Yangibana Rare Earths Project

Response to Submissions on Environmental Review Document

Assessment Number 2115
EPBC 2016/7845

18 April 2019

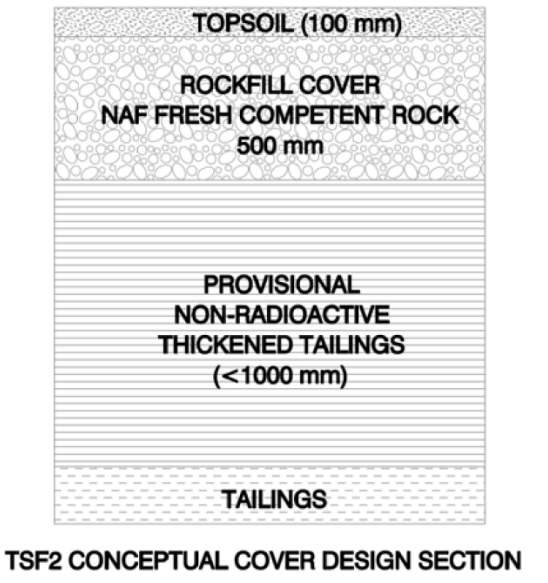
N o.	Submitter	Submission and/or issue	Response to comment	EPA Services/Agency comment on response (Feb 2019)	Proponent Response																												
		43 of the Radiation Baseline Report (Appendix 5-4 to the ERD) does indicate that further analysis was conducted but this appears to be only for one sample for Ra-226, Ra-228 and Pb-210 and the laboratory analysis is not included in that report or in the monitoring and analysis results in Appendix 1 to that report.

N o.	Submitter	Submission and/or issue	Response to comment						EPA Services/Agency comment on response (Feb 2019)	Proponent Response
			Sample descriptor			SIPHO N	BHW0 5	FRW03		
			Sample date	LO R	UNI TS	25/02 /18	25/02 /18	25/02/1 8		
			Radium 226	0. 2	Bq/L	<0.2	<0.2	<0.2		
			Radium 228	0. 2	Bq/L	<0.2	<0.2	<0.2		
			U-238	0. 00 1	Bq/L	<0.00 1	0.424	0.175		
			Th-232	0. 00 1	Bq/L	<0.00 1	<0.00 1	<0.001		
			K-40	2	Bq/L	<2	<2	<2		
			Gross alpha	0. 05	Bq/L	0.10	2.11	0.74
